## Riley Purgatory Bluff Creek Watershed District Permit Application Review

Permit No: 2024-006

**Project:** Watercourse and Wetland Restoration – The applicant is seeking a permit to restore excavation in a wetland and downstream watercourse as part of a Wetland Conservation Act restoration order issued to the owners of both properties.

**Location:** 1811 and 1851 Lake Lucy Lane, Chanhassen, MN

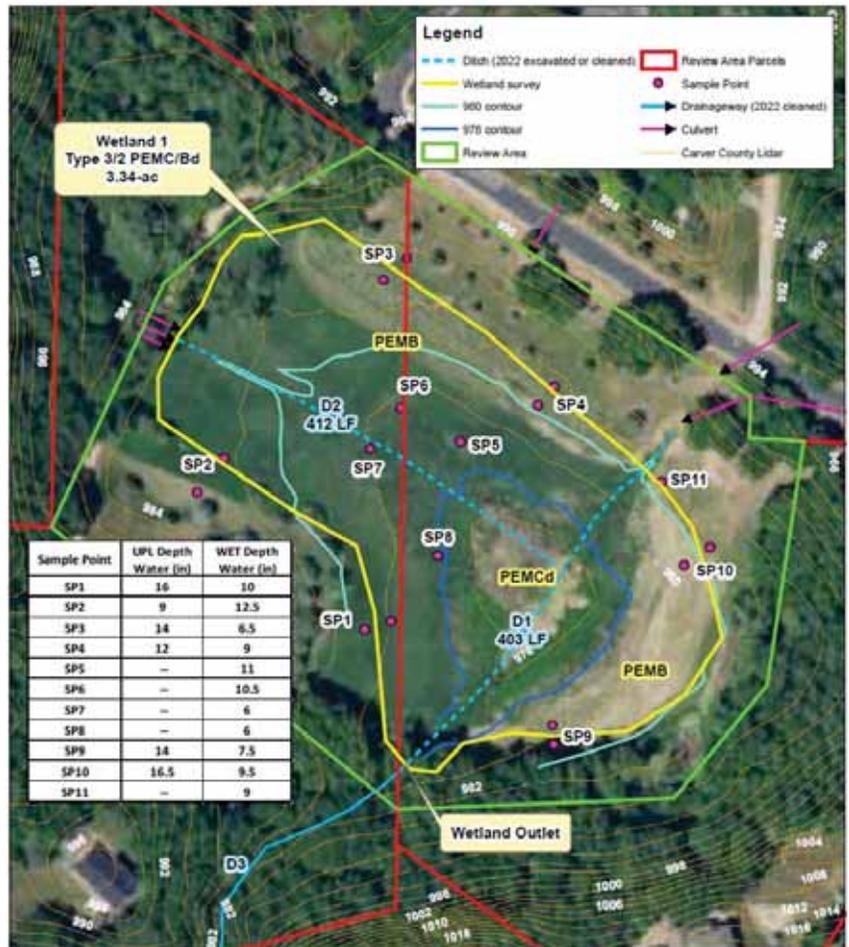
The erosion control plan prepared by Sathre-Bergquist, Inc includes installation of sediment control logs, a rock berm construction entrance, daily inspection, placement of a minimum of 6 inches of topsoil, erosion control blanket, decompaction of areas compacted during construction, and retention of native topsoil onsite to the greatest extent possible. To conform to RPBCWD Rule C requirements, the following revisions are needed:

- C1. The Applicant must provide the name, address and phone number of the individual who will remain liable to the District for performance under this rule and maintenance of erosion and sediment-control measures from the time the permitted activities commence until vegetative cover is established. This information is required prior to issuance of the permit.

Survey Revised Figure 2 - Existing Conditions (6-18-2021 FSA Photo)

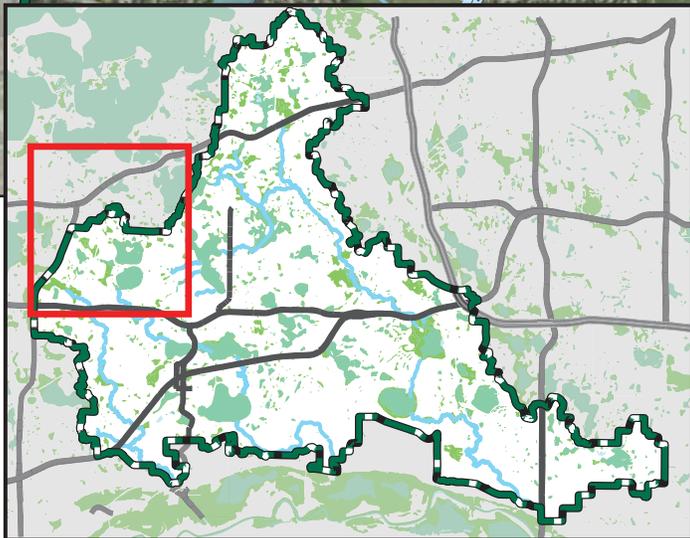
Because the proposed work triggers a permit under RPBCWD Rules B, F and G and there is a delineated wetland protected by the state Wetland Conservation Act disturbed by the proposed construction activities, Rule D, Subsections 2.1a and 3.1a require buffers around the entire wetland (a wetland map is provided below for reference).

Because the proposed land-disturbing activities are on existing single family residential properties, Rule D, subsection 3.2.d requires 20-foot average, 10-foot minimum buffer widths. The buffer widths from the project plans are summarized in the following table and demonstrate conformation with to Rule D, subsection 3.2.

The plan requires revegetating disturbed areas within the proposed buffer with native vegetation, thus conforming with Rule D, Subsection 3.3. The plan sheets show that buffer markers will be placed per District criteria (Subsection 3.4). A note is included on the plan sheet indicating the project will be constructed so as to minimize the potential transfer of aquatic invasive species (e.g., zebra mussels, Eurasian watermilfoil, etc.) to the maximum extent possible conforming to Rule D, Subsection 3.6.

- D1. Before any work subject to District permit requirements commences, buffer areas and maintenance requirements, including locations of buffer markers, must be documented in a

declaration recorded after review and approval by RPBCWD in accordance with Rule D, Subsection 3.5.
